City Council Staff Report

SUBJECT: APPROVAL OF VARIOUS ACTIONS RELATED TO THE JAMES O. JESSIE DESERT HIGHLAND UNITY CENTER OUTDOOR PERFORMANCE STAGE AND OUTDOOR BALL FIELD LIGHTING PROJECT, CITY PROJECT NO. 14-18

CITY OF PALM SPRINGS CONTRACT CHANGE ORDER

Date: July 25, 2016
Project No:14-18
Project: James O. Jesse Outdoor Performance Stage
& Outdoor Ball Field Project
Change Order No: 04
Purchase Order No: 16-0975

Figure 2

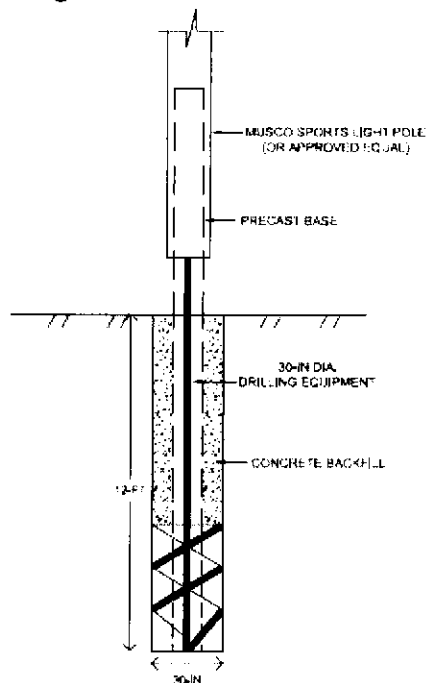
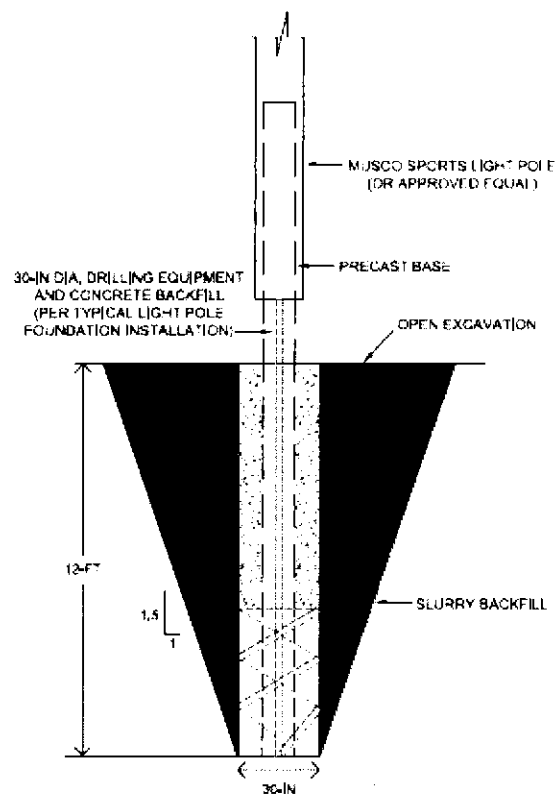
The normal installation of these 70-foot tall light towers requires drilling with an auger to prepare a 30" diameter foundation embedded 12 feet deep into undisturbed natural ground, as generally shown in Figure 2.

The City's geotechnical engineering report for the excavations required for the Musco light pole towers to be installed for the new outdoor ball field lighting identified the potential for cobble and boulders within the subgrade, which could prevent drilling and augering of the light tower foundations, and would require open excavations. Staff identified an additional scope of work in the original bid documents that would establish an agreed price per light pole foundation for open excavation if cobbles and boulders were encountered that prevented drilling and augering as specified. The additional work via open excavation would require use of excavation equipment, backfill with concrete slurry, and re-drilling and augering into the concrete slurry to provide the 30" diameter foundation embedment for the 70-foot tall light towers, as generally shown in Figure 3.

Drilled foundations for the sports lighting to be installed on the project have been modified to an open excavation procedure due to the presence of cobbles in the existing soils, which has caused refusal of the drilling operation for the sports lighting foundations. Sports lighting foundations will be open excavated to a depth of 1 foot deeper than the planned drilled excavation and the open excavation will be filled with Controlled Density Fill (CDF) or Type 100-E-100 concrete backfill. Foundations will then be drilled through the CDF or concrete backfill.

STANDARD DRAWING FOR TYPICAL LIGHT POLE FOUNDATION - DRILLING

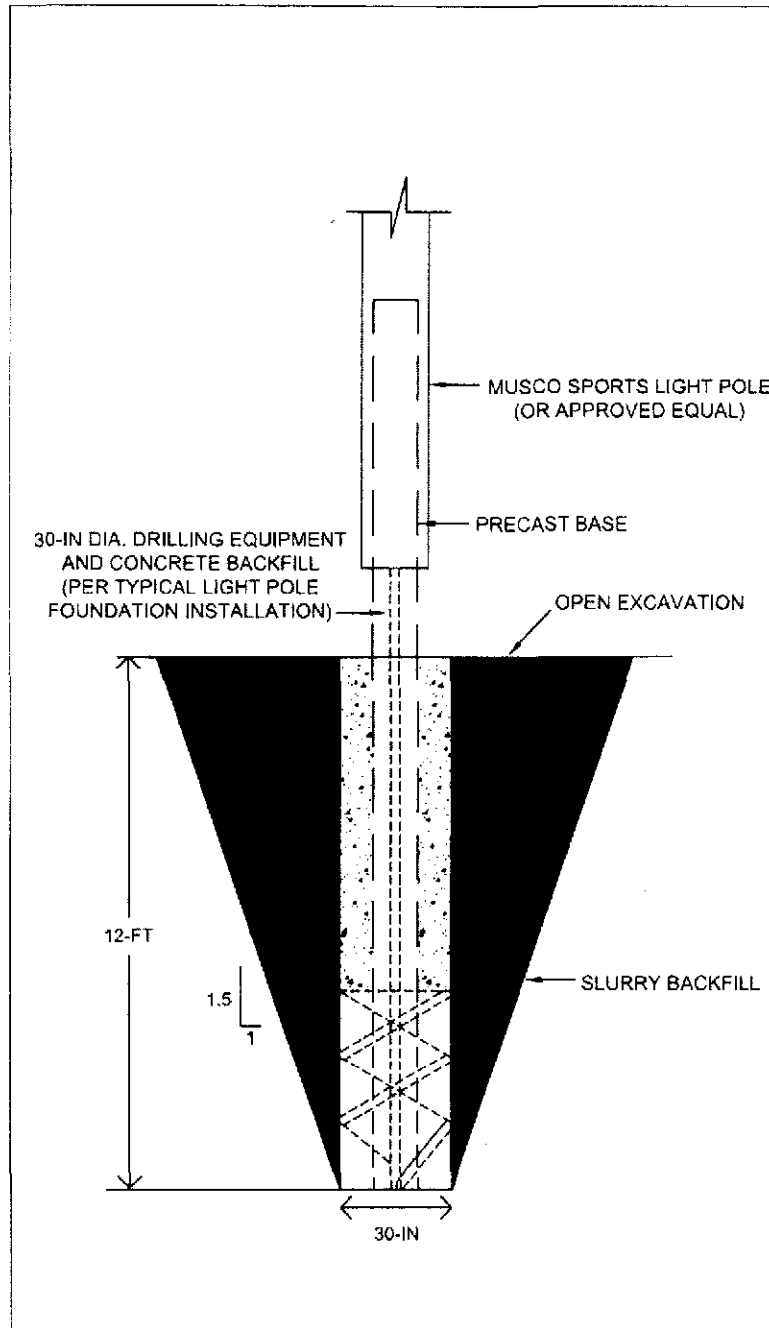
The soils investigation report that was provided at bid time to the contractor also indicated the presence of cobble in many of the borings that were performed. There were two details provided in the specifications entitled "Standard Drawing for Typical Light Pole Foundation – Drilling" and "Standard Drawing for Alternate Light Pole Foundation – Excavation". Both details are attached for reference.
